TECHNICAL BULLETIN No. 80 DATE: 16/01/09

SUBJECT: Temporary Fix of LCD32XR8DA Hum

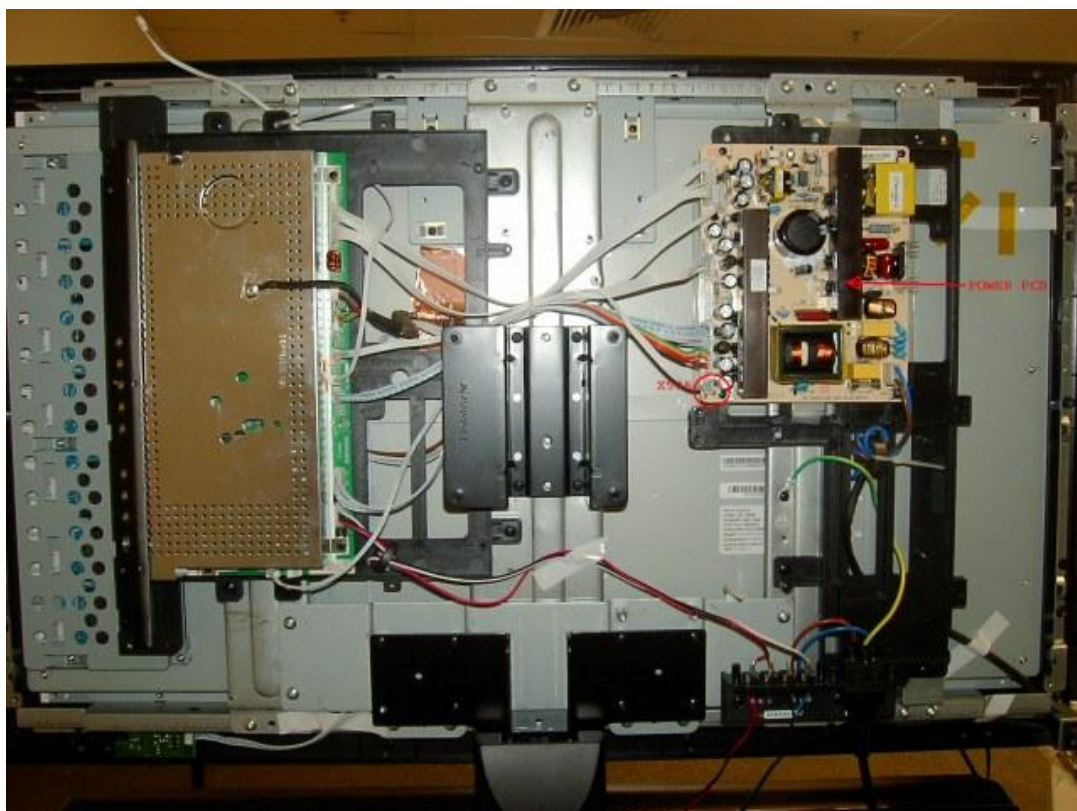
Backlight (inverter) circuit generates ripple on 24V supply line, due to incorrect PWM voltage level.

Increase PWM voltage level by disconnecting pin 2 (middle pin) of **X506** on **Power Supply** PCB.
